RICHARDSON BELLAMY & BENTON  
CHARTERED ARCHITECTS  
11 EXCHANGE RYDGE, WINDSOR, BERKS.

DATE MAY 1971  
SCALE 1/100  
REVISION NO. 1/1250

THE WHITE HOUSE FITZJOHN'S AVENUE HAMPSTEAD  
PROPOSED ALTERATIONS AND ADDITIONS TO STAFF ACCOMMODATION

GROUND FLOOR PLAN.

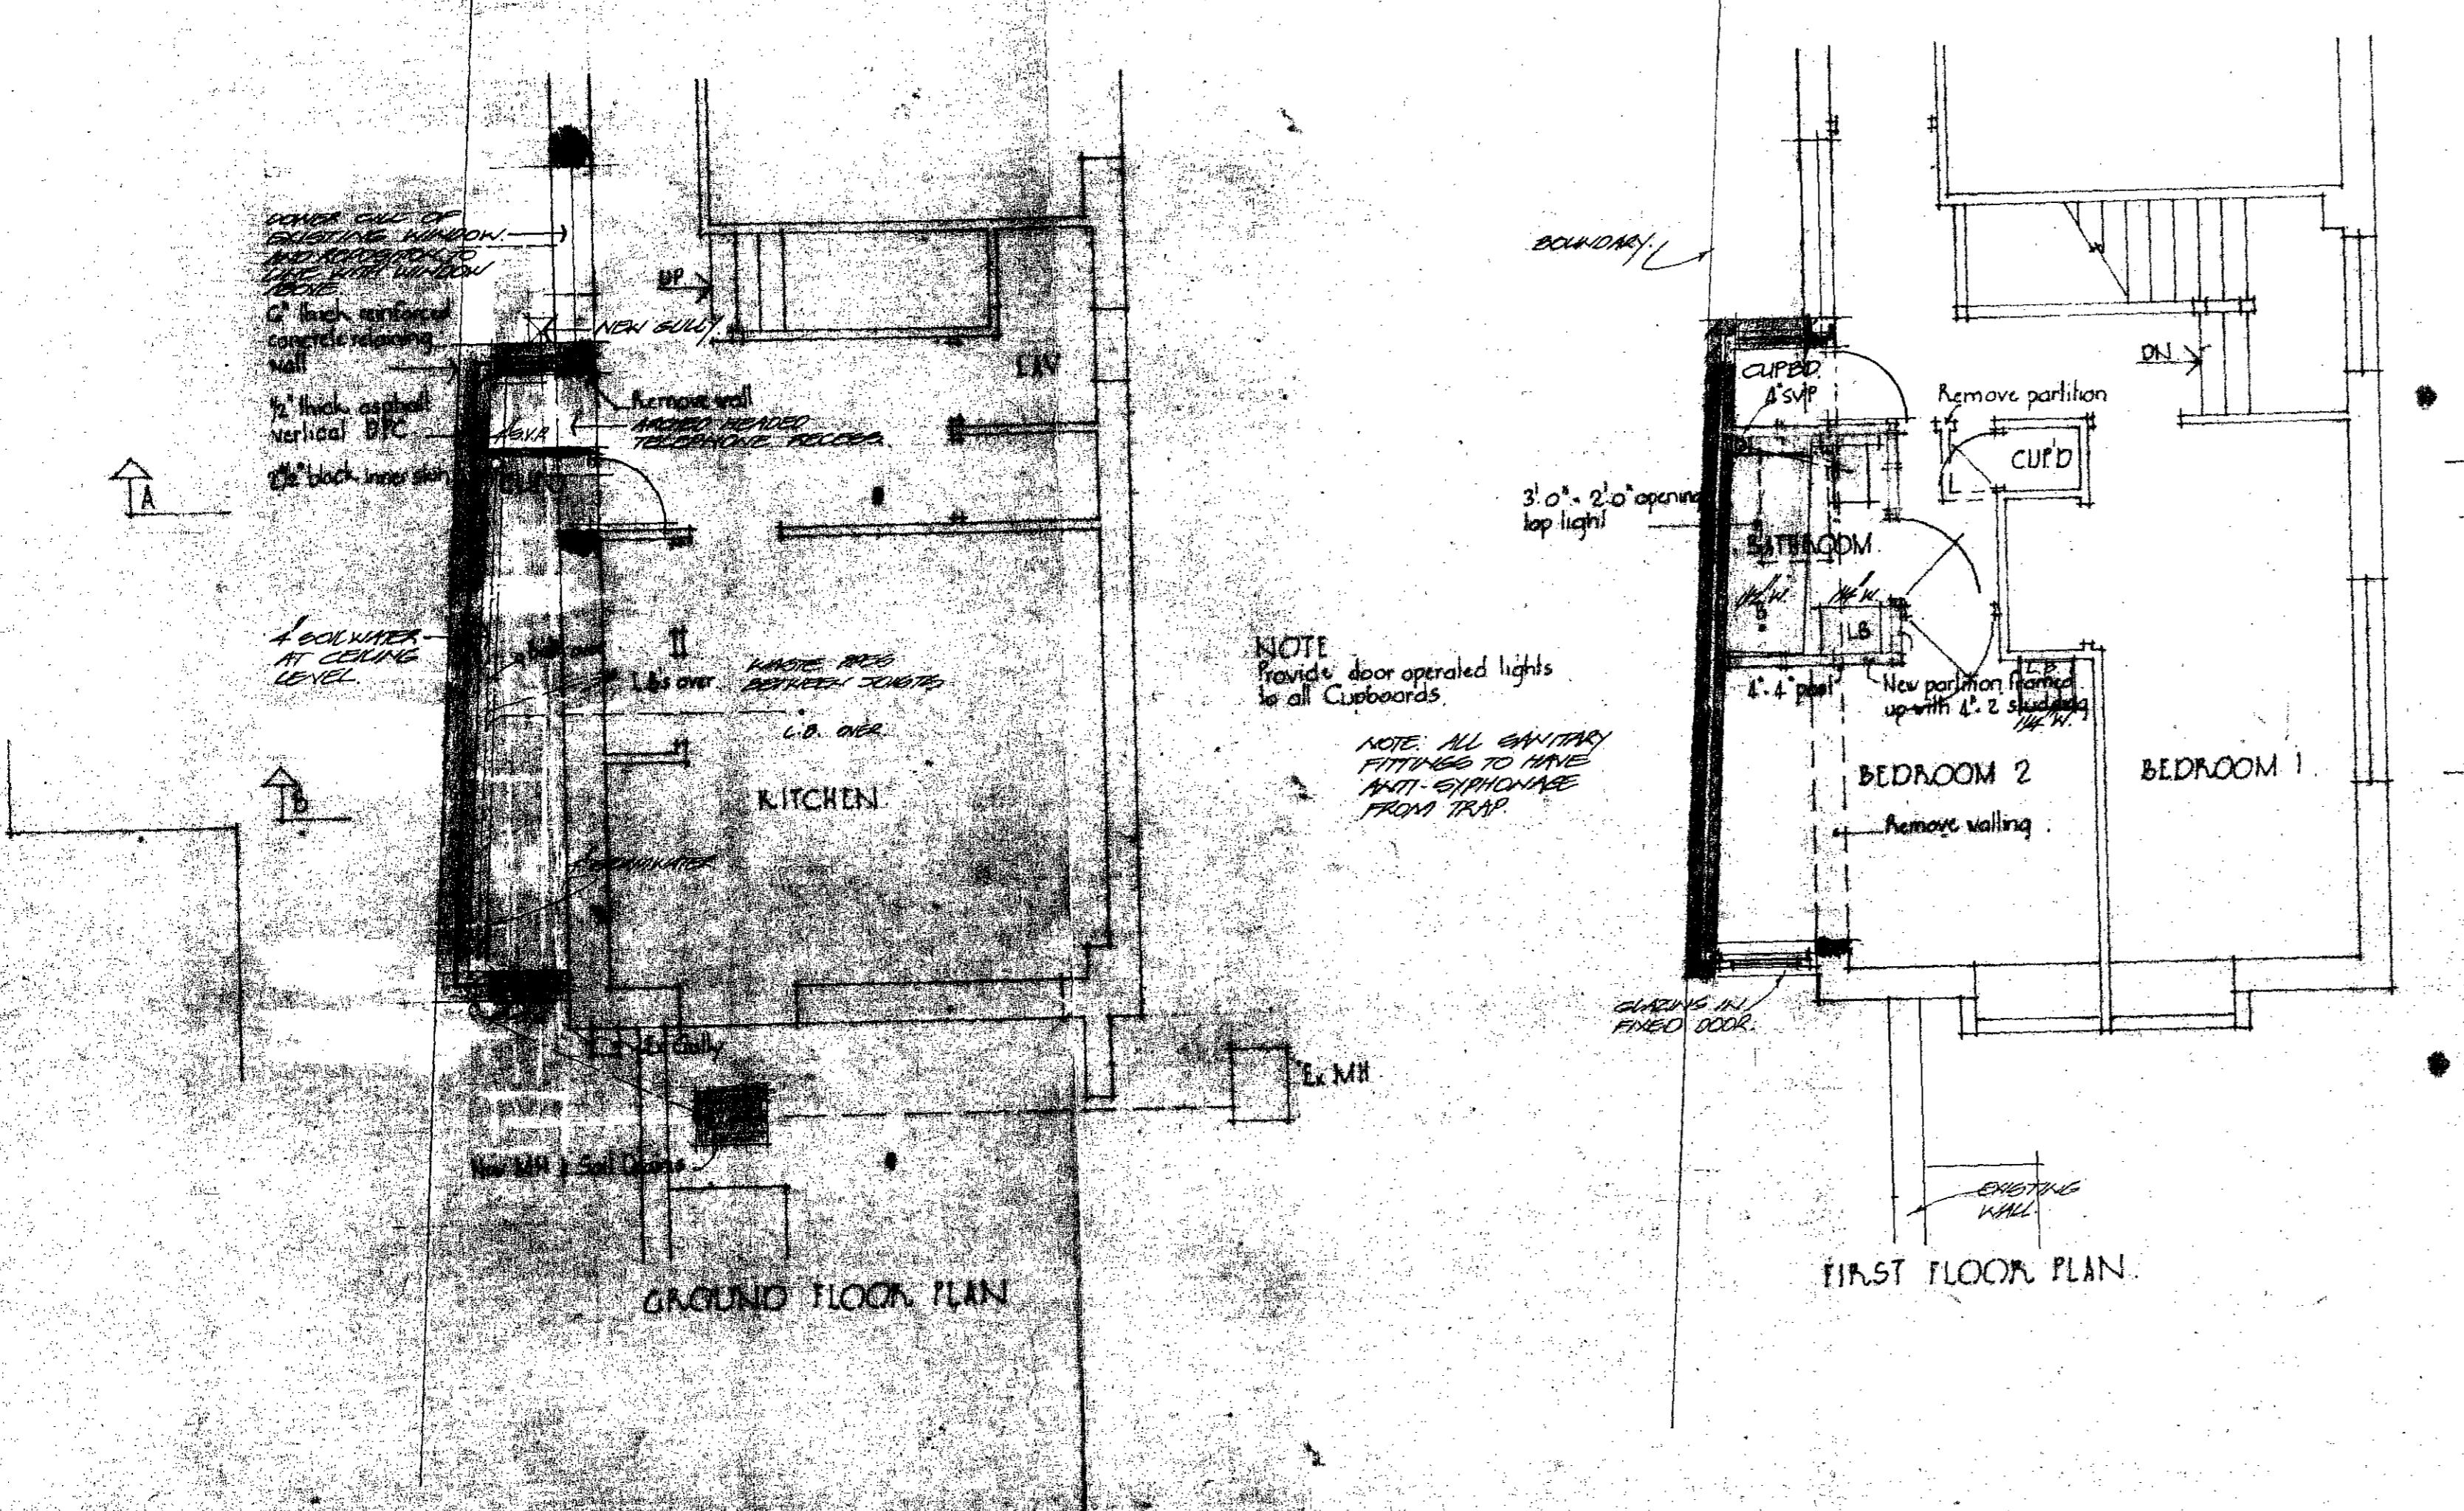
AMENDMENTS 26.7.72  
 1. ADJUSTING TO LHS BOUNDARY.  
 2. EXISTING WALL BREND FOR ACCESS TO FRONT.  
 3. GLAZING IN FIRE DOOR TO FIRST FLOOR.  
 4. VENT DUCT ADDED TO NORTH-EAST ELEVATION  
 AT GROUND & FIRST FLOOR.  
 5. RELOCATING DOOR TO GROUND FLOOR  
 6. DOOR TO KITCHEN.  
 7. CUPBOARDS REMOVED ON FIRST FLOOR, EXCEPT  
 KITCHEN & PANTRY.  
 8. DOOR ADDED TO PANTRY.  
 9. PLUMBING ADDED.  
 10. EXISTING UNITS ADDED.

Amendments 28.7.72  
 9. inner skin of retaining wall altered to 8½'  
 10. position of new door altered  
 11. door to kitchen altered at NW corner  
 12. Dark space behind retaining wall omitted  
 13. alterations to area side wall deleted.
